## UNITED STATES PATENT AND TRADEMARK OFFICE

APPLICATION NO. FILING DATE FIRST NAMED INVENTOR ATTORNEY DOCKET NO. CONFIRMATION NO. 10/647,873 08/22/2003 Robert L. Doubler 2131.022 3190 21917 7590 12/01/2004 **EXAMINER** MCHALE & SLAVIN, P.A. STEWART, ALVIN J 2855 PGA BLVD PALM BEACH GARDENS, FL 33410 ART UNIT PAPER NUMBER 3738

\$
		Application No.	Applicant(s)
Office Action Summary		10/647,873	DOUBLER ET AL.
		Examiner	Art Unit
	The MAIL INC DATE AND	Alvin J Stewart	3738
The MAILING DATE of this communication appears on the cover sheet with the correspondence address Period for Reply			
A SHORTENED STATUTORY PERIOD FOR REPLY IS SET TO EXPIRE 3 MONTH(S) FROM THE MAILING DATE OF THIS COMMUNICATION.  - Extensions of time may be available under the provisions of 37 CFR 1.136(a). In no event, however, may a reply be timely filed after SIX (6) MONTHS from the mailing date of this communication.  - If the period for reply specified above is less than thirty (30) days, a reply within the statutory minimum of thirty (30) days will be considered timely.  - If NO period for reply is specified above, the maximum statutory period will apply and will expire SIX (6) MONTHS from the mailing date

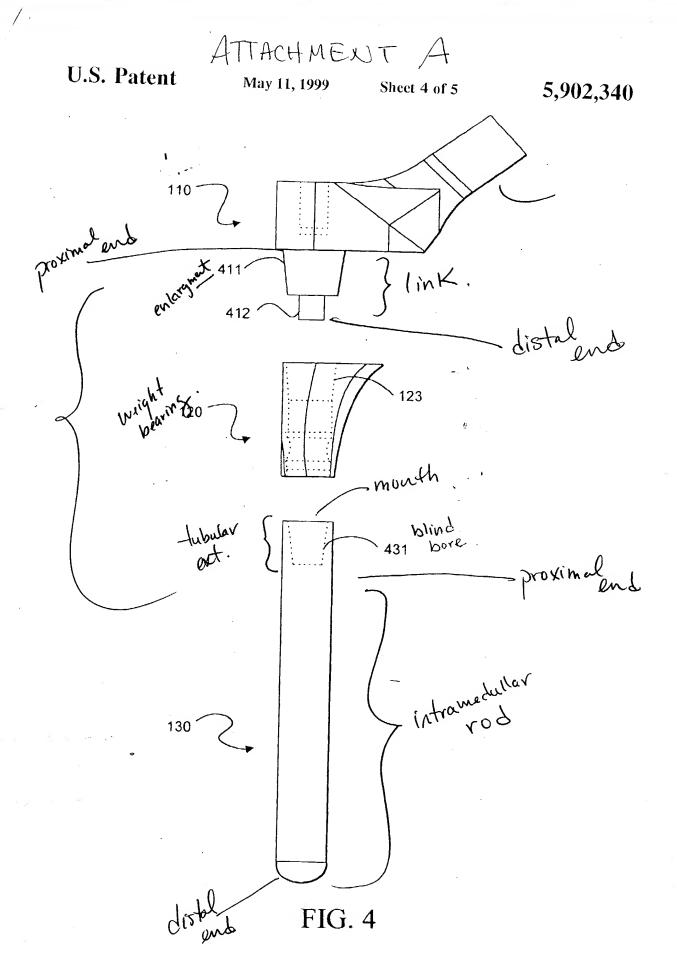
White et al discloses a modular implant (see Fig. 4) comprising a link (411 & 412), a weight bearing (120), an intramedullary rod (130), a tubular extension (see attachment A), a mouth, a blind bore (431) and an enlargement (411). The link has a proximal and distal ends (see attachment).

ATTACHMENT B

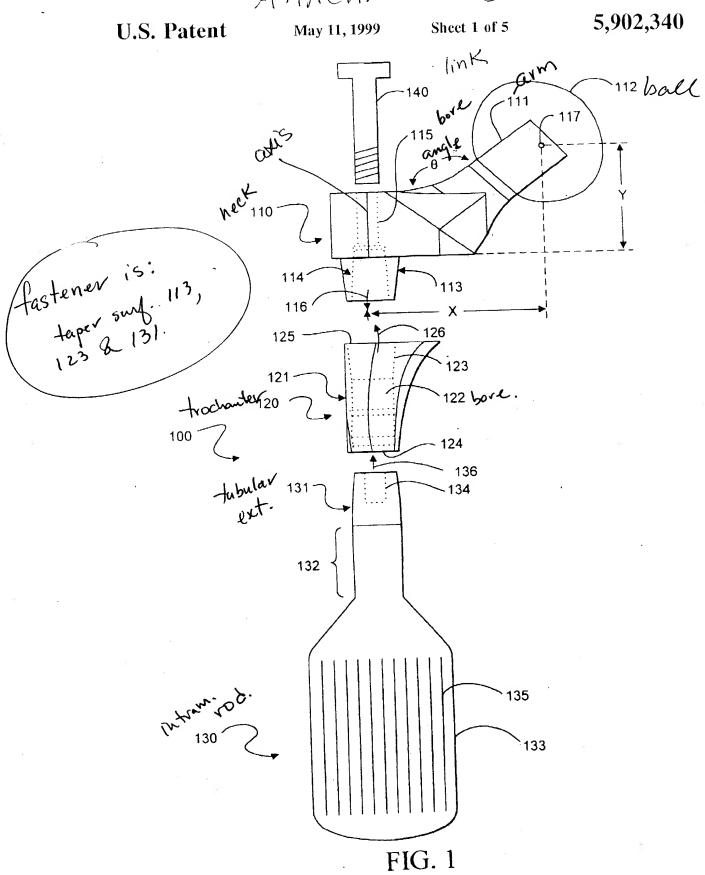
Regarding claims 5-7, see attachment B & C disclosing each structure limitation.

US 6,299,648 B1

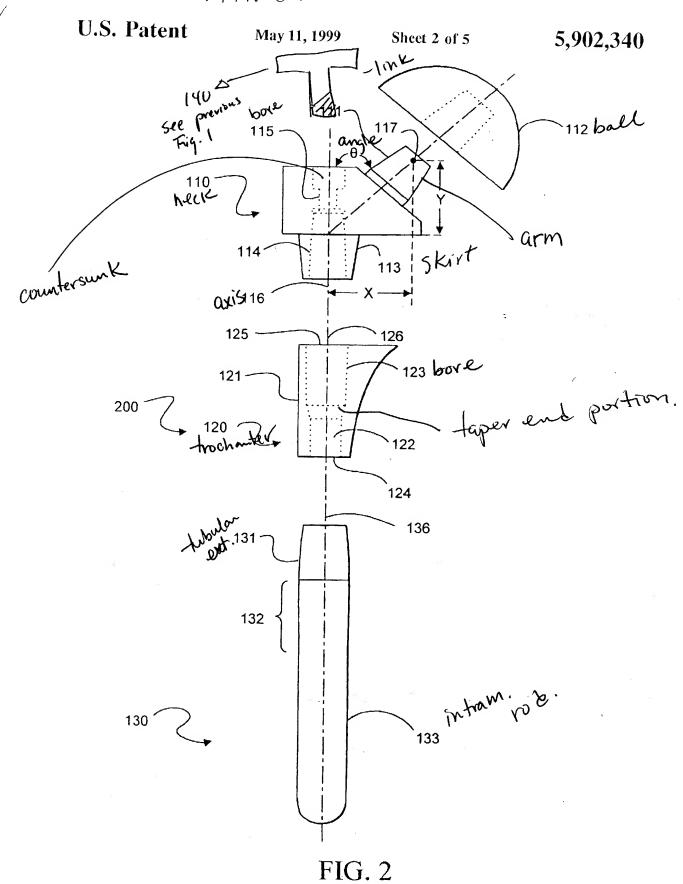
Doubler et al discloses a modular implant (see Fig. 1) comprising a link (13), a trochanter (16), an intramedullary rod (11), a tubular extension (28), a fastener (50), a neck (41), a skirt (31), a bore and a bore being countersunk (see attachment). The link has a proximal and distal ends (see attachment).

Regarding the sub-assembly being relatively movable, the link, the tubular extension and the intramedullary rod all are movable. The three structures above are capable of being moved at the same time. In order to overcome the rejection the Applicant's representative has to clarify the link and intramedullary rod are capable of move independently relative to each other.

Regarding claim 8, the link and the trochanter are non-rotationally connected when the bolt (50) is tightly connected with the rod.
